HILLIARD PLANNING AND ZONING BOARD MEETING

TUESDAY, FEBRUARY 13, 2024, 7:00 PM

SUBJECT: Planning and Zoning Board approval of the Site Plan Application No. 20221025.
Parcel ID No. 17-3N-24-2020-0057-0000. Address 3714 Raven Drive.
Property Owner- Gregg Simmons

HILLIARD RV	
EXISTING CONDITIONS	
Date:	06/2022
Designer:	HAV
Job #:	21-071
Drawn:	MRP
Scale:	1:60
Sheet:	3

Sheet: **15**

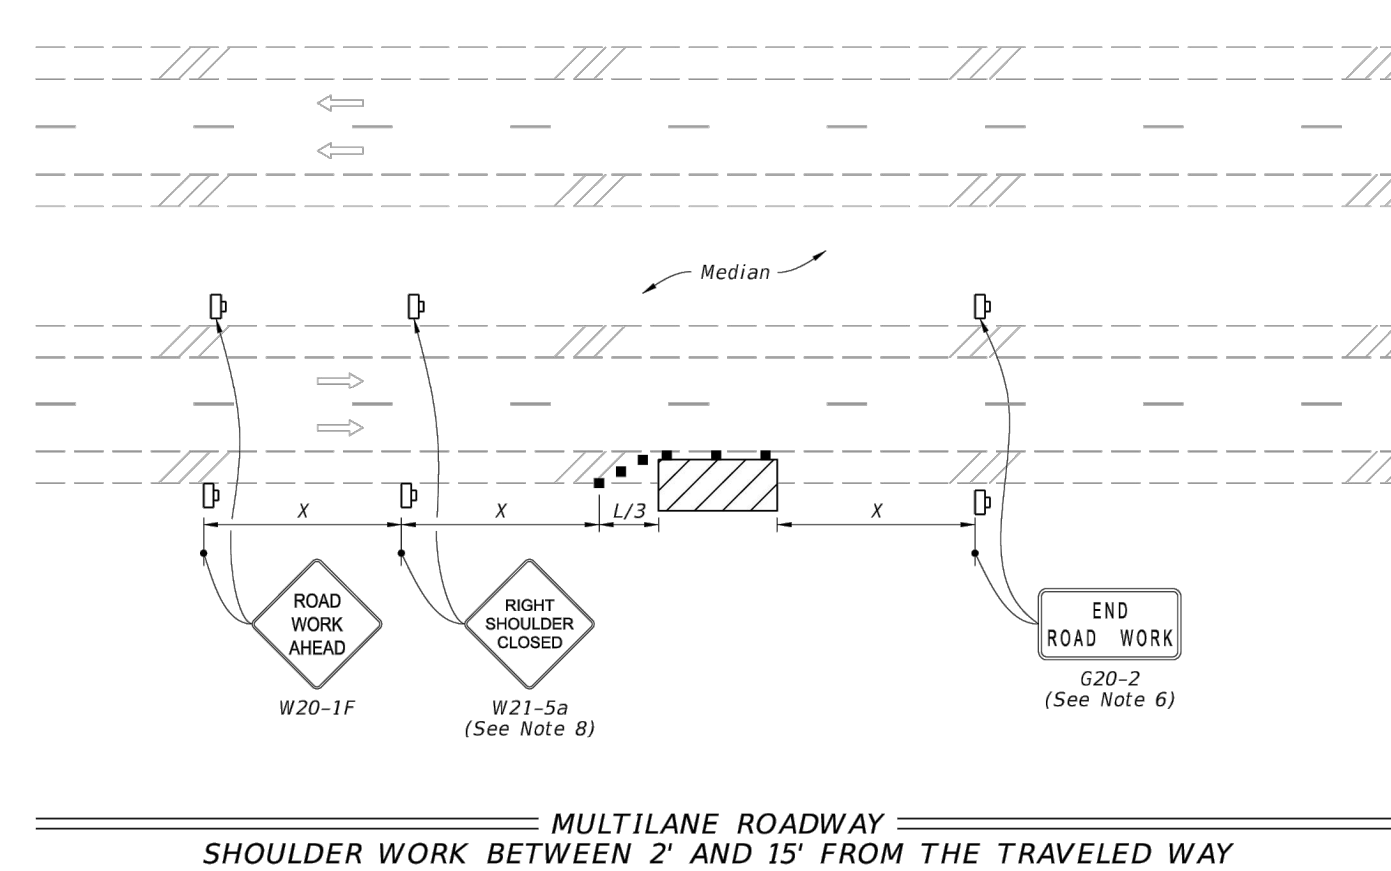
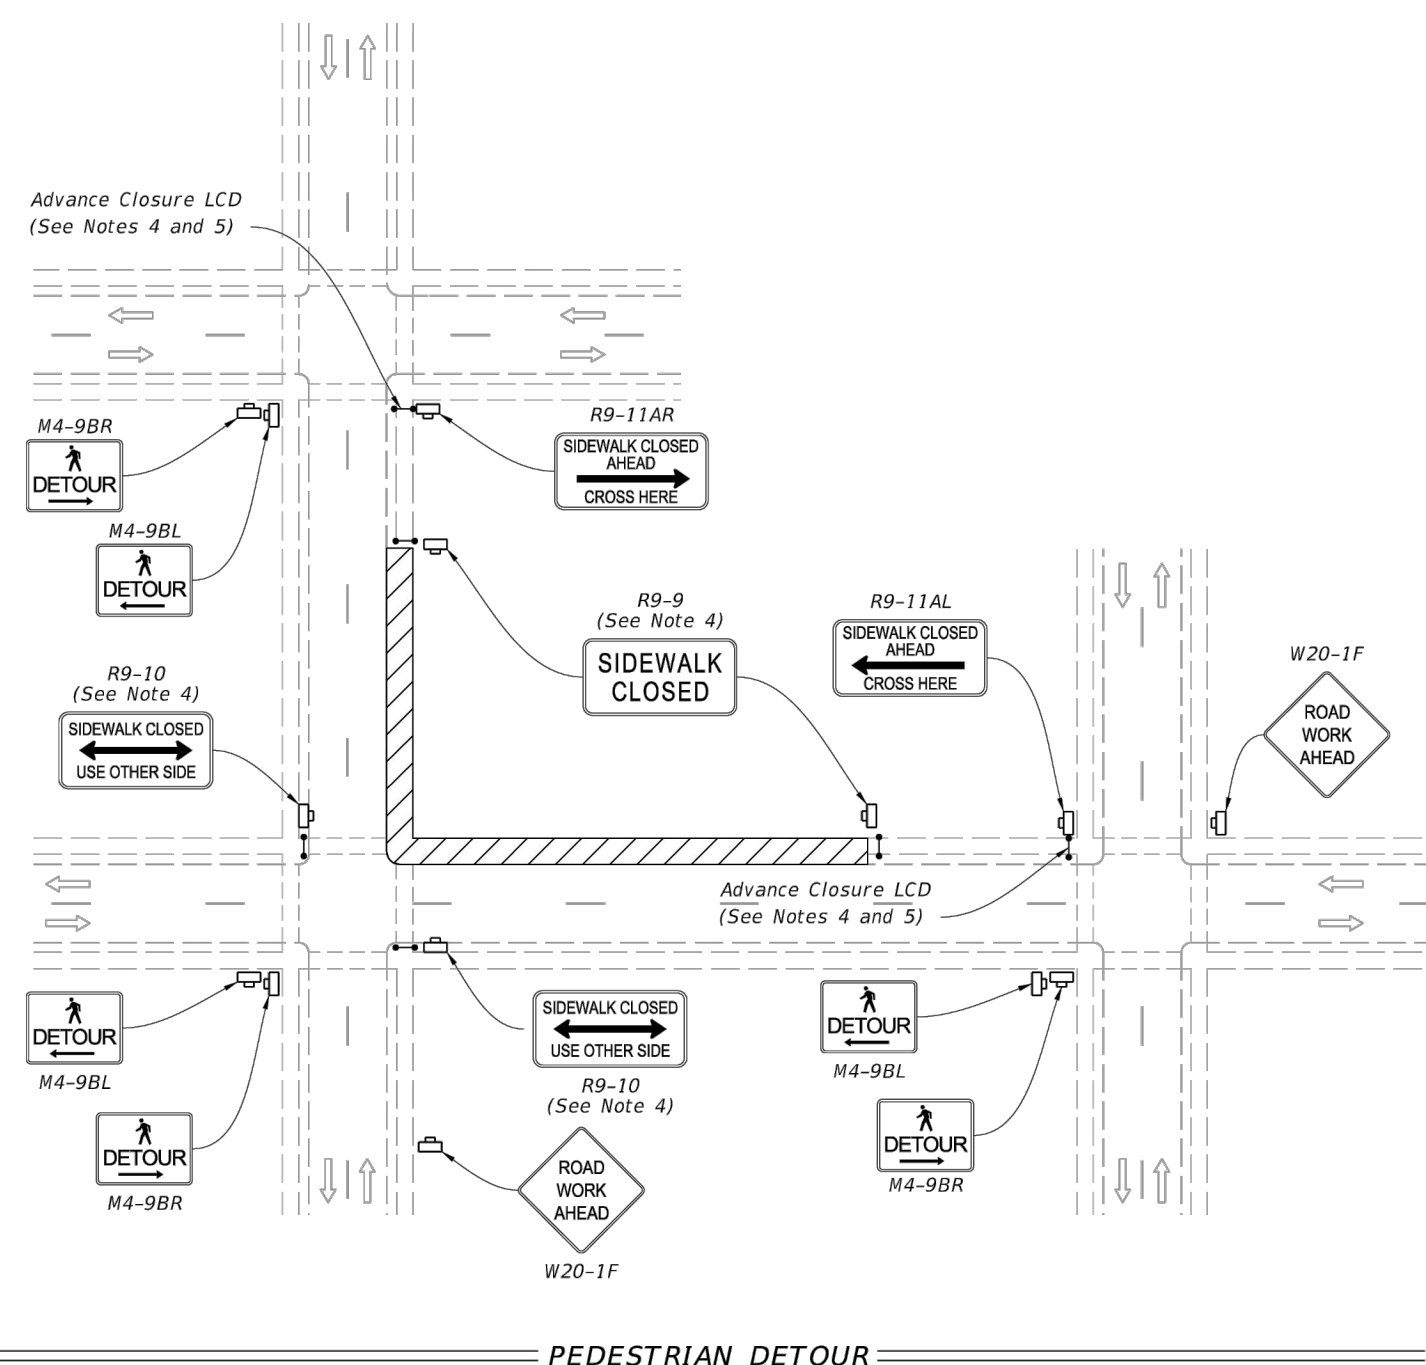
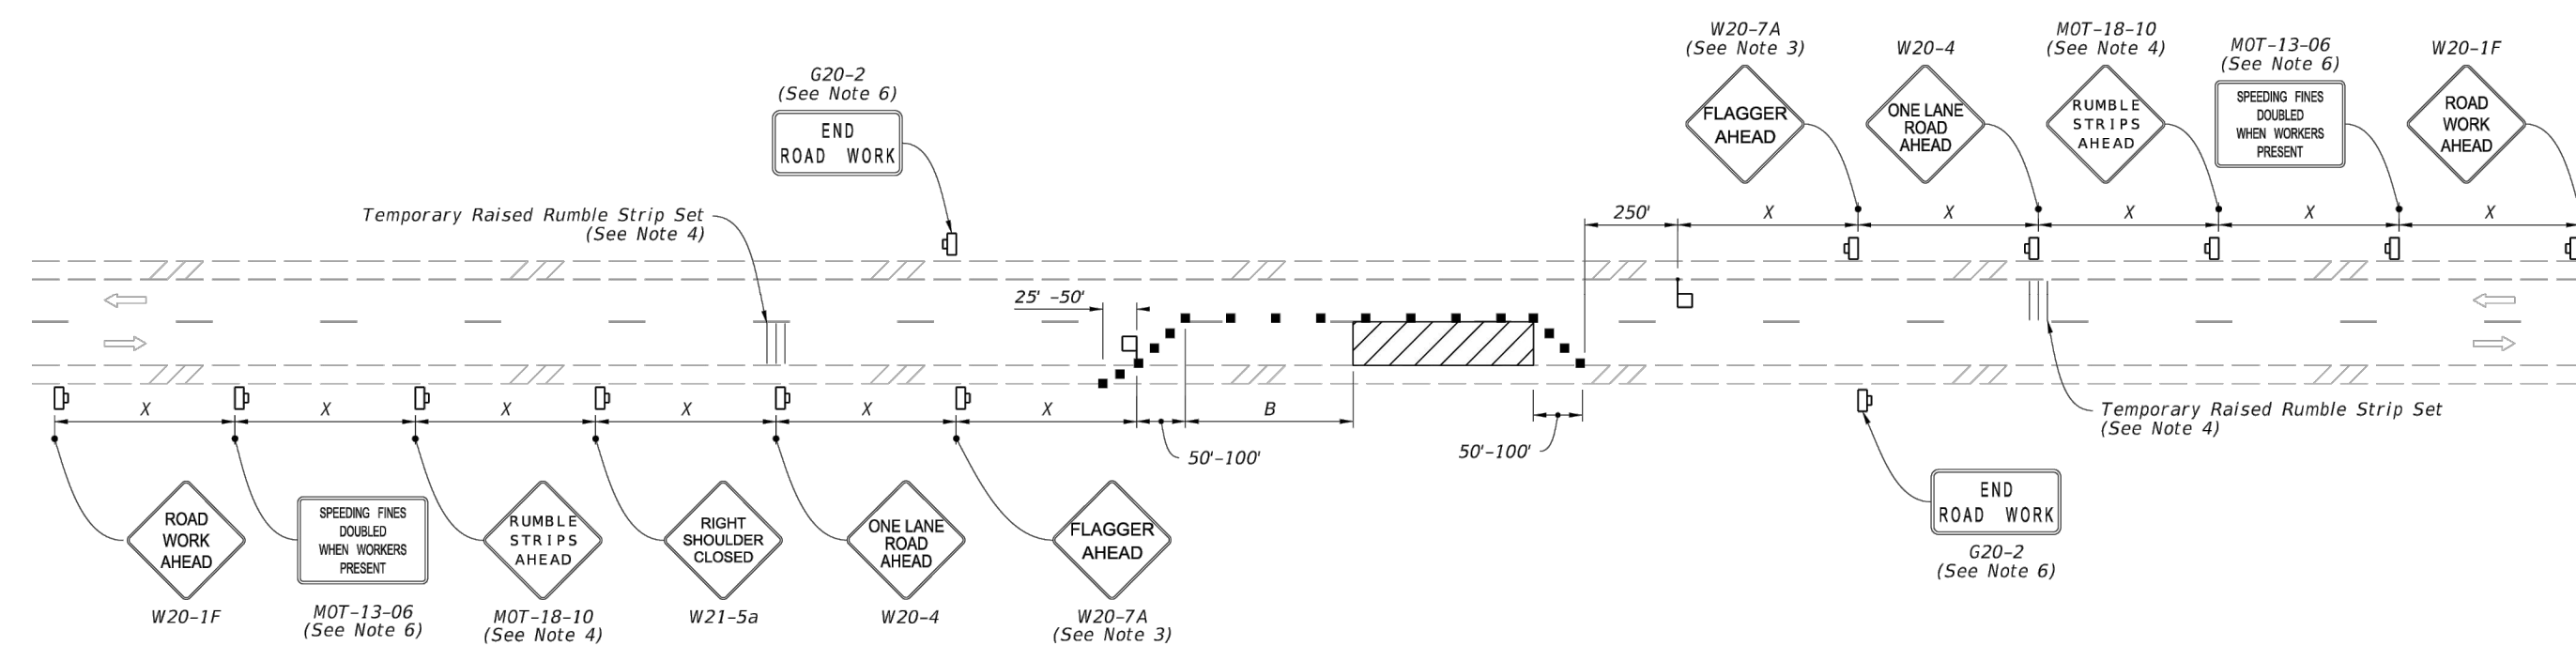
1. See Note 1 for Sheet 7 - Site Plan. Address, as needed.

Only a small revision is needed on Sheet 15. Revise 1- $\frac{1}{4}$ " to 1- $\frac{1}{2}$ " in two places. See image below. Once revised and sent back to me, I'll add an approval stamp to the plans.
